**ADDENDUM
NO. 2**

**HAYES LEONARD ELEMENTARY SCHOOL CHILLER, BOILERS, AND
MISCELLANEOUS WORK
Valparaiso, IN 46385**

ADDENDUM TWO

Addendum Two (AD.02) to the drawings and specifications prepared by Gibraltar Design and The Skillman Corporation for **Hayes Leonard School Mechanical Upgrades and Related Work** for Valparaiso School Corporation, Valparaiso, Indiana.

© GIBRALTAR DESIGN SHEET
M-100A

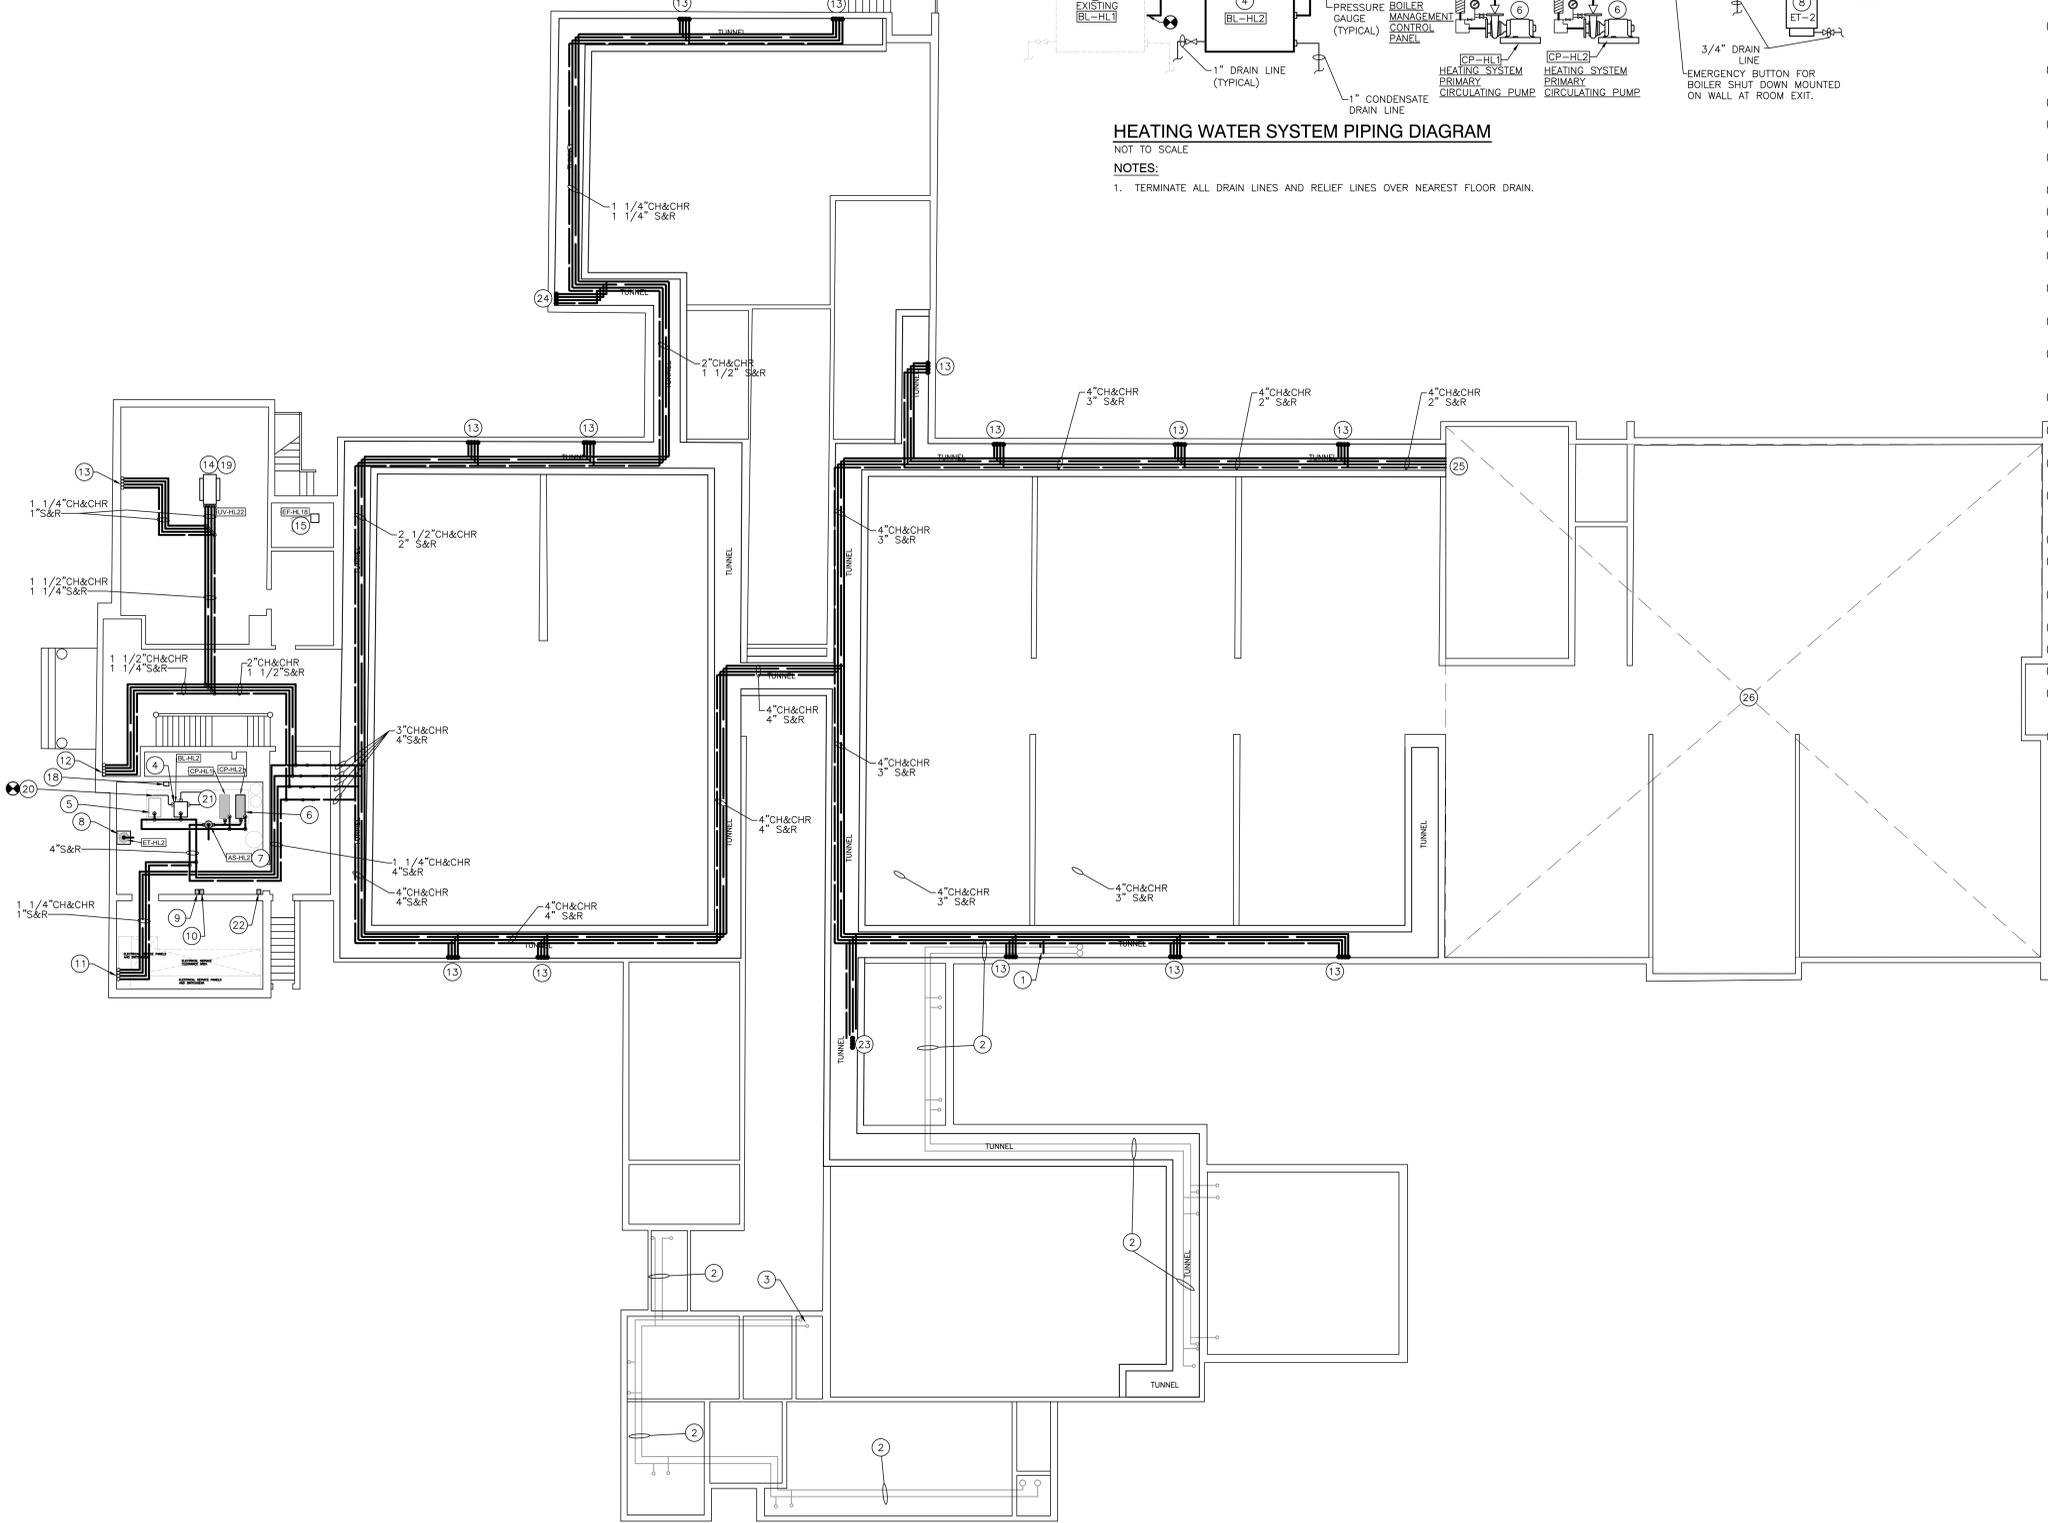
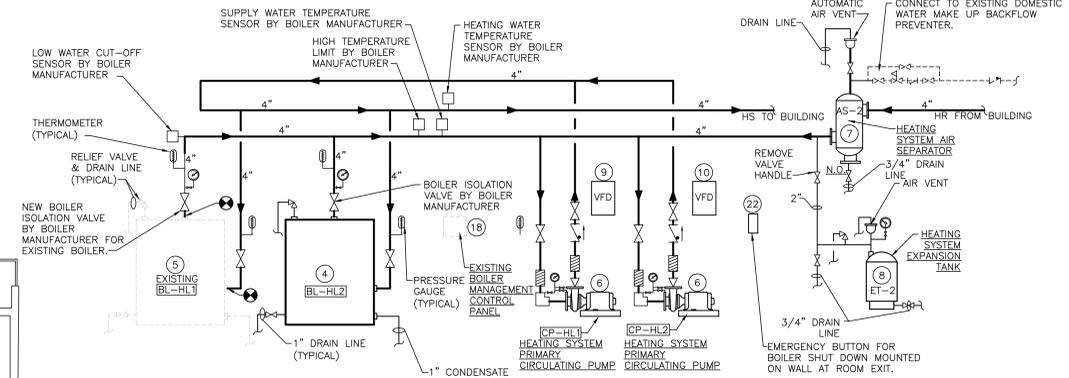
- A. ALTERNATE NO. 1: Reference the new Sheet M-100A for the Lower Level Tunnel Plan drawings indicating the running of the selective new Ventilator Unit that are directly above the tunnels and all associated piping runs and sizing. **Base Bid:** No Piping is run in the tunnels.

4. Sheet M-100A

- A. Refer to newly issued, full size drawing sheet included in this Addendum for added clarification of Alternate Scope of Work.
